Response to

Request for Additional Information No. 34, Revision 0

U. S. EPR Standard Design Certification

Docket No. 52-020

15.02.08-9-1—FWLB Representative Small Break – Vapor Void Fraction at the Break

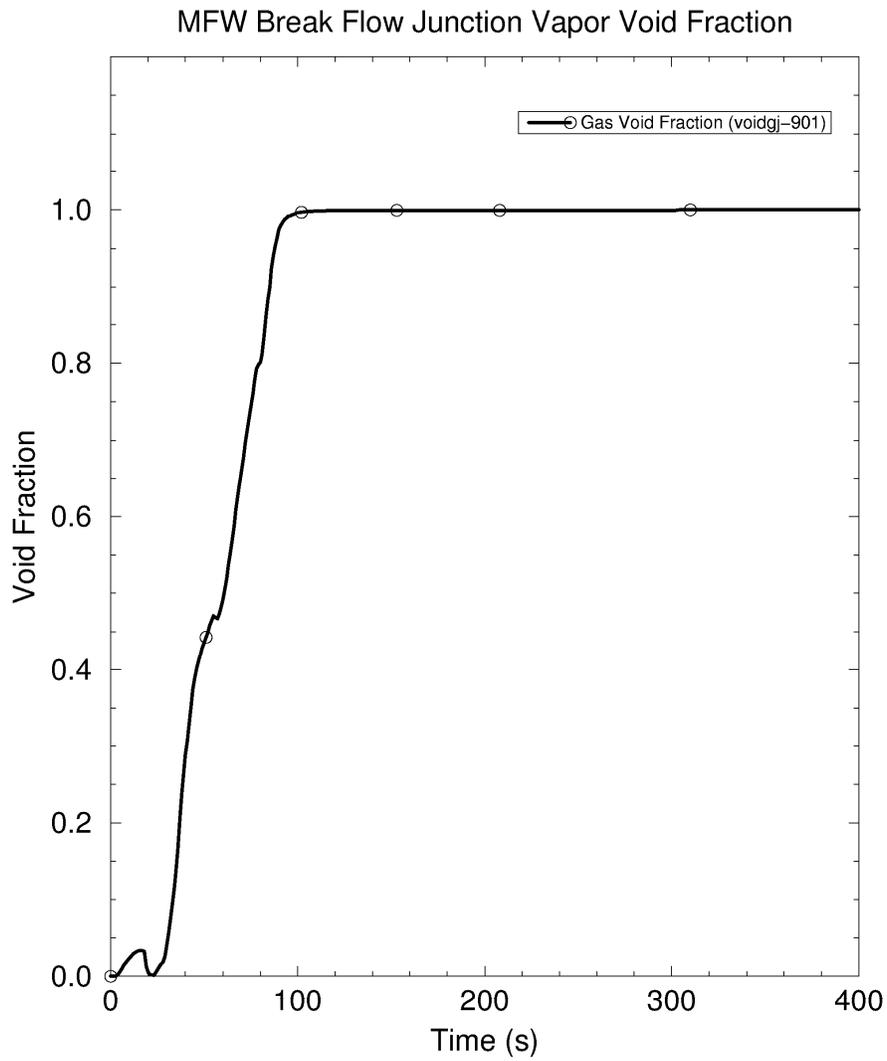
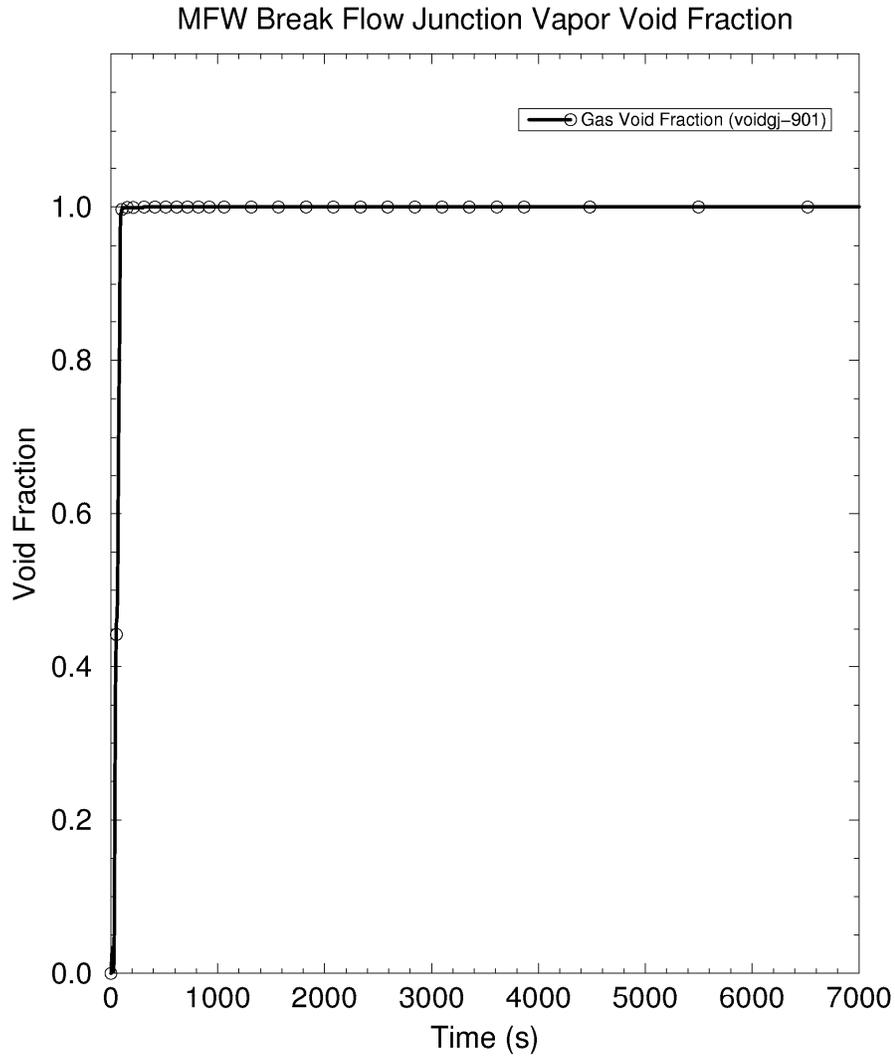
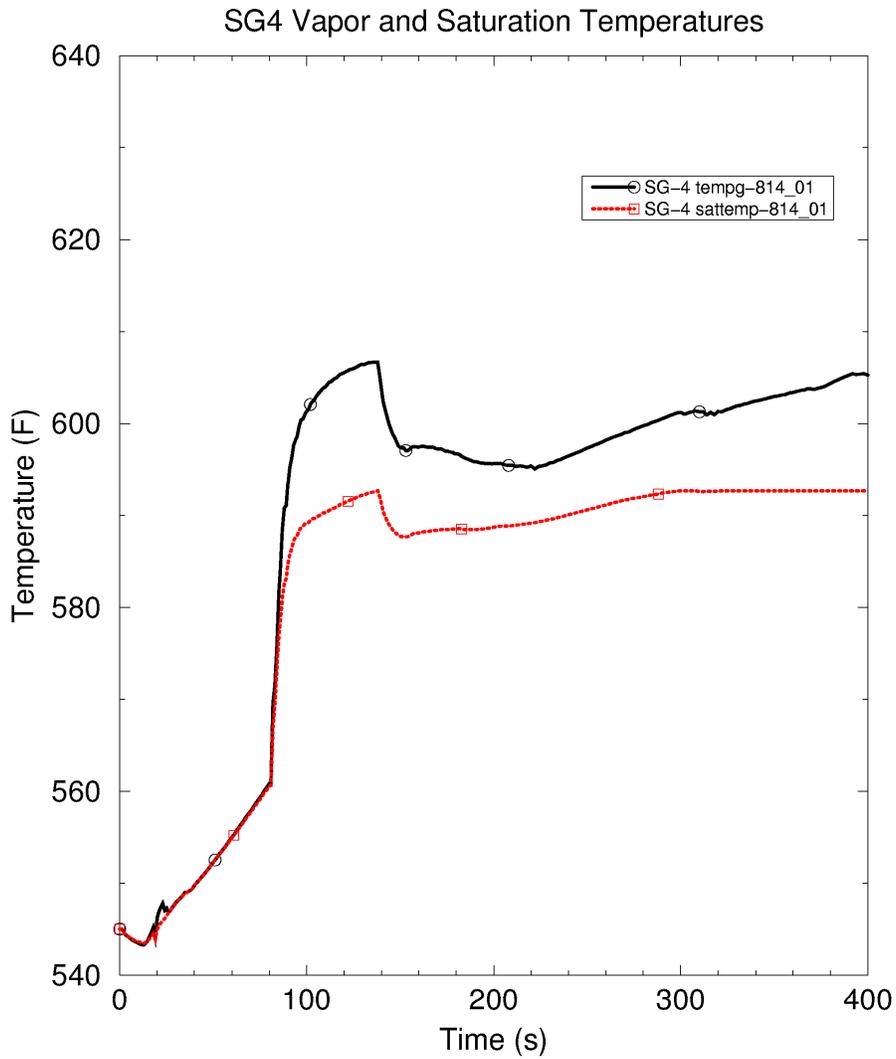
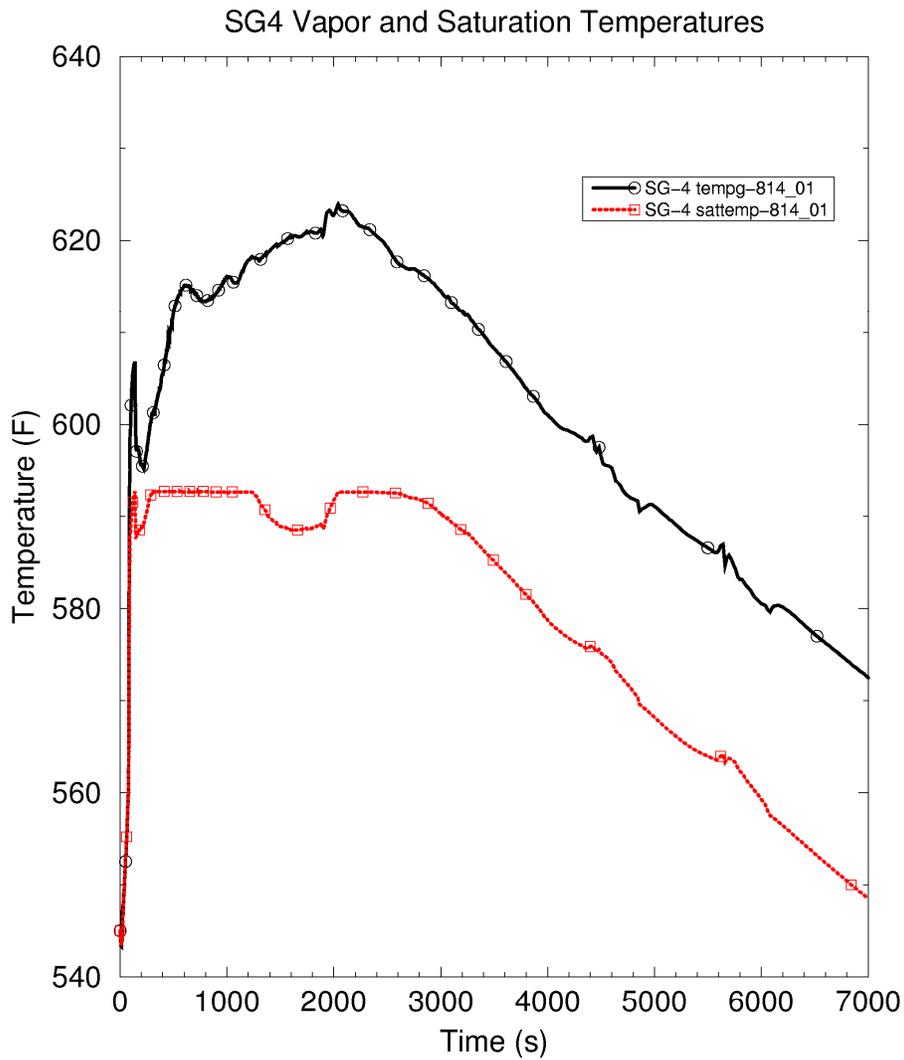
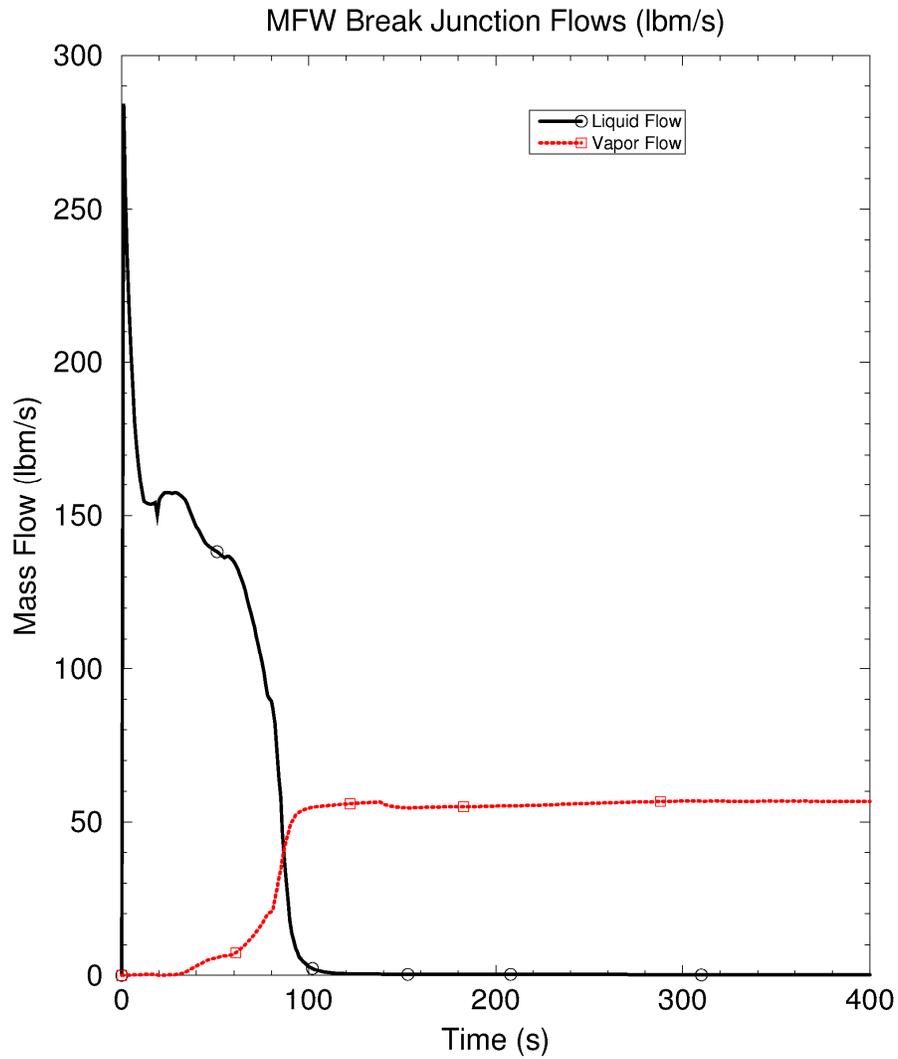
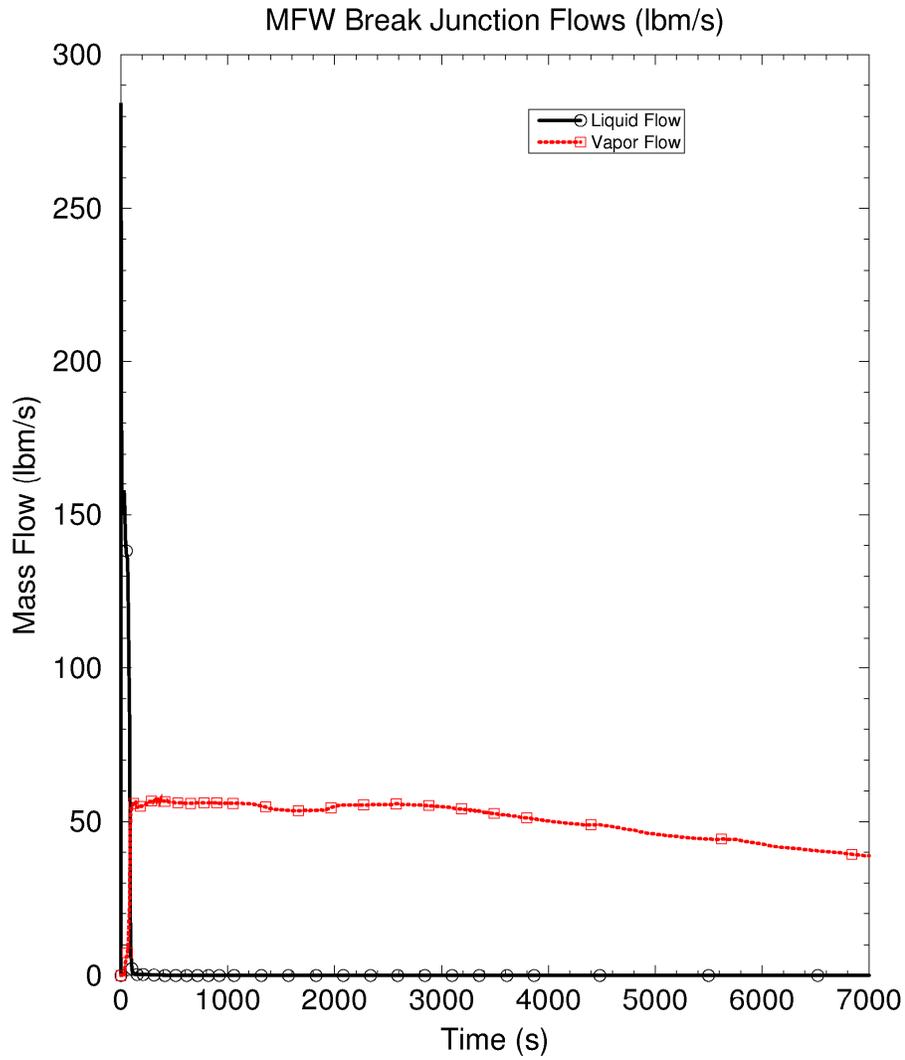
For the break flow in Figure 15.2-58 “FWLB Representative Small Break – Break Flow”, explain how the break flow area was determined. Please explain the criterion used for determining the worst break size. Provide the flow quality as well as the fluid-phase temperatures at the break opening. In addition, provide the liquid- and vapor-phase mass flow rate at the break and specify the break backpressure used in the calculations. Use a logarithmic scale over an appropriate range in displaying quantities that vary significantly in magnitude (15.2.8 Section III).

A spectrum of break sizes is investigated that ranges from the minimum break size that could be overfed by the main feedwater (MFW), 0.0184 ft², to the area of the MFW distribution half-ring inlet, 0.922 ft². The representative small break results presented produce the maximum pressurizer level.

The break flow is determined by S-RELAP5 utilizing the single velocity Moody critical break flow correlation with a forward loss coefficient of 1.0 and a reverse loss coefficient of 0.5. The containment pressure (i.e., break backpressure) is fixed at 14.7 psia.

The void fraction at the break opening is provided in attached Figure 15.02.08-9-1 (time scale to 400 seconds) and Figure 15.02.08-9-2 (time scale to 7000 seconds). The vapor phase temperature and saturation temperature in the break upstream volume is provided in attached Figure 15.02.08-9-3 (time scale to 400 seconds) and Figure 15.02.08-9-4 (time scale to 7000 seconds). The liquid and vapor mass flows are provided in Figure 15.02.08-9-5 (time scale to 400 seconds) and Figure 15.02.08-9-6 (time scale to 7000 seconds).
